Access Compliance Report

Public Rights-of-Way

(Curb Ramps)

Intersection ID: 43523	Main Street: WIND_CHIME_CT	Cross Street: MISTRAL_WY	Location:	W
ADA ID: F55679248996	Ramp Type: BlendTrans1	Initial Pass/Fail: Fail	Overall Compliance: No	Severity Score: 10

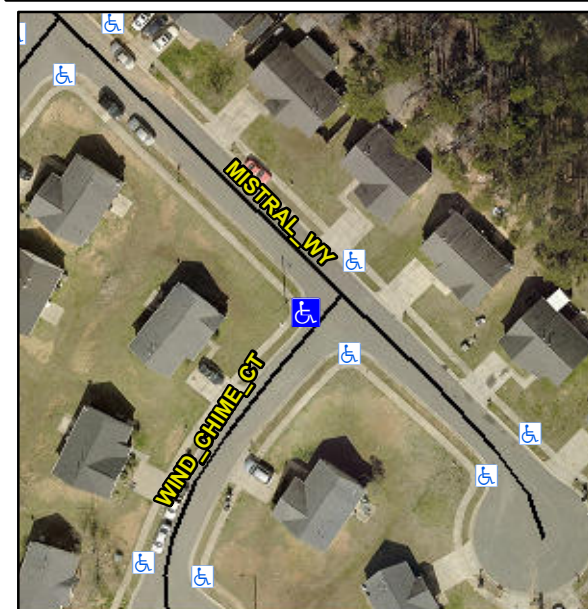
CURB LIP 0.5

Not Found, R304.5.1, R304.5.3

Remove & Replace Curb Ramp With Two New Directional Ramps or Equivalent.
